DMC Apparels Ltd

4 November 2025

Observation-01: Inconsistency in the design report. [Block-J (Factory Building)]

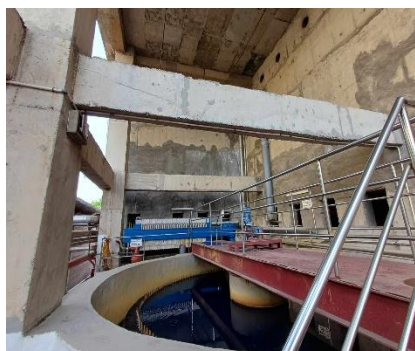
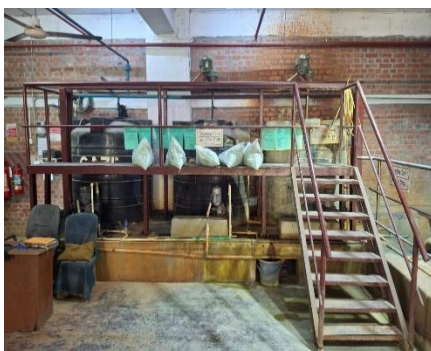
Description: A set of design documents was available. The report did not include shear wall, retaining wall, and slab adequacy checks. Detailed calculation of wind and seismic calculations, FEM assignment & base reactions comparison, structural irregularity checks, and IMRF framing checks were not incorporated in the design report.

The building engineer is required to update the design report in full compliance with BNBC and submit it to RSC for detailed review.

Observation 03: Void in concrete retaining wall. [Block-J (Factory Building)]

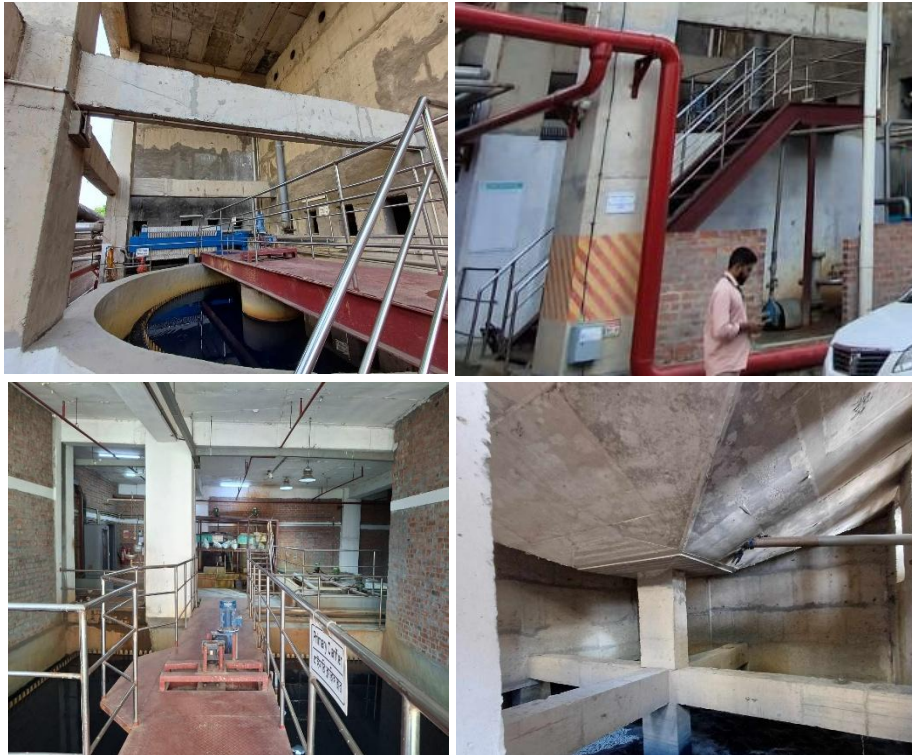
Description: During the inspection, rectangular and circular concrete voids were found in the ETP retaining walls. The voids were not shown in the provided drawing.

The building engineer is required to verify whether any main re-bar has been compromised due to the voids and assess the adequacy of the retaining wall, considering the impact of these voids. The findings, along with the updated design report, shall be submitted to RSC for review.

Observation 05: Hairline cracks were found in the 6th-floor columns and roof beam-slab.
[Block-J (Factory Building)]

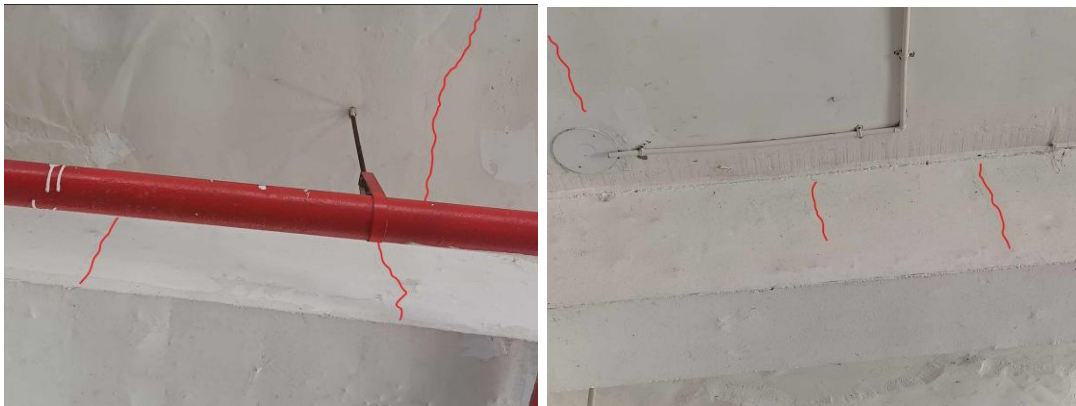
Hairline crack on the column

Hairline crack on beam-slab

Description: During the inspection, hairline cracks were observed on the 6th-floor columns and roof beam-slabs. The cracks may propagate due to poor construction workmanship.

The building engineer is required to investigate the cracks and prepare an investigation report with proper remediation methodology and submit it to RSC. The factory is required to repair the crack as per the investigation report after receiving the acceptance from RSC.

Observation 09: Lack of lateral load transfer media and inconsistency in the design report.
[Block-K (Compressor Room)]

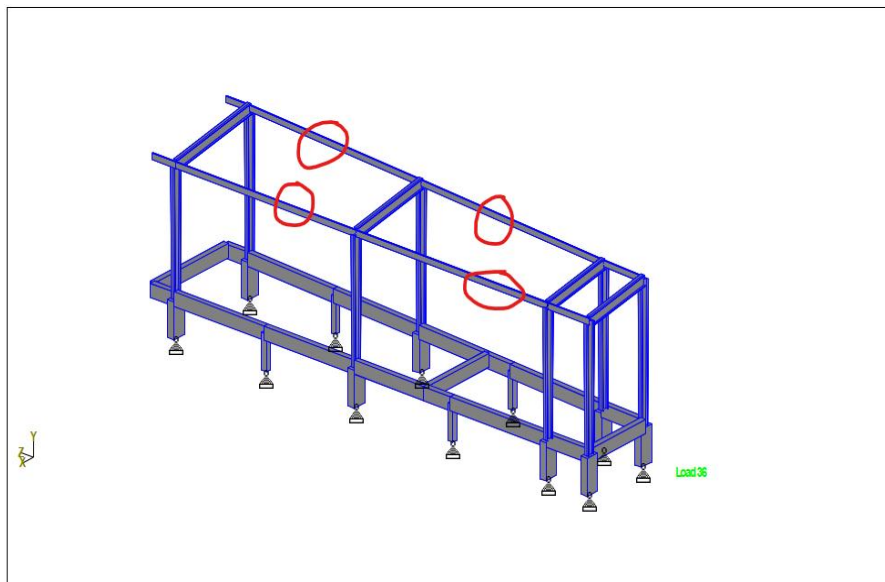
No lateral load transfer media in long direction

Lateral load transfer media are considered in the long direction for the analysis and design report

Description: Lateral load transfer media in the long direction is missing, only the rafter is available in the short direction in each grid. However, it is considered in the analysis and design report.

The building engineer is required to review the design and the lateral stability of the shed considering the on-site condition.
